Conceptual Zoning Site Plan

Cumberland Parkway Site - Cobb County, GA

PETITION NO: Z-93

ZONING COMMENTS:

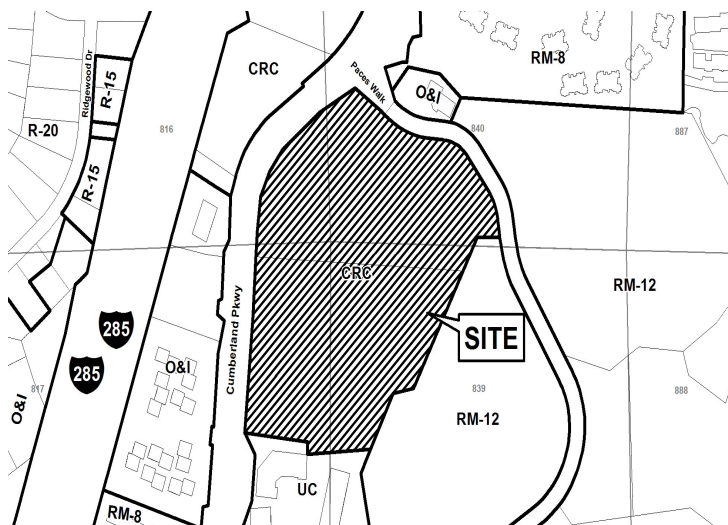
Applicant is requesting the Regional Retail Commercial zoning district for the purpose of a mixed use development consisting of 300 apartment units, 50 condominium units, 225 assisted senior living units, 200 age restricted units, a 300-room hotel, and 101,103 square feet of retail to include a supermarket and other retail uses. The proposed buildings will be 5-6 stories in height with 2 or 3 levels of parking underneath, as shown on the site plan. The residential density would be 41 units per acre.

The proposed plan will require a contemporaneous variance to waive the front setback from the required 50 feet to 25 feet. The applicant also needs to reduce the 50-foot landscape buffer along the east and south property lines to allow the access drives.

1. This site is located at the southeast intersection of Cumberland Parkway and Paces Walk. The parcel has been cleared and pad-graded with all but the remaining natural slopes draining to the north across Paces Walk near this intersection into the Vinings Chase Lake.
2. Stormwater management will be provided using underground facilities.
3. As indicated in the downstream conditions comment section, there is a private lake located downstream of the site (Vinings Chase Lake). A pre- and post-development sediment survey will be required to evaluate any sediment impact to the lake.

Recommend a deceleration lane on Cumberland Parkway for the entrance.

Recommend applicant verify that minimum intersection sight distance of 490' is available for Cumberland Parkway entrance. Recommend restricting right turns on red if sight distance requirement can not be achieved at the signalized intersection.

Recommend signalized entrance directly align with the development across the street on Cumberland Parkway.

Recommend a westbound right-turn lane at Paces Walk and Cumberland Parkway, as recommended in the Traffic Impact Analysis (DRI #2620).

Based on the above analysis, Staff recommends **APPROVAL** for residential portion of the application, **DENIAL** of the commercial portion in Parcel A, and deletion from the application of Parcels B, C and D, subject to the following conditions:

1. Final site plan be approved by the Board of Commissioners;
2. Maximum of 16 units per acre;
3. Variances requested in Zoning Comments section;
4. Water and Sewer Division comments and recommendations;
5. Stormwater Management Division comments and recommendations; and
6. Department of Transportation comments and recommendations.
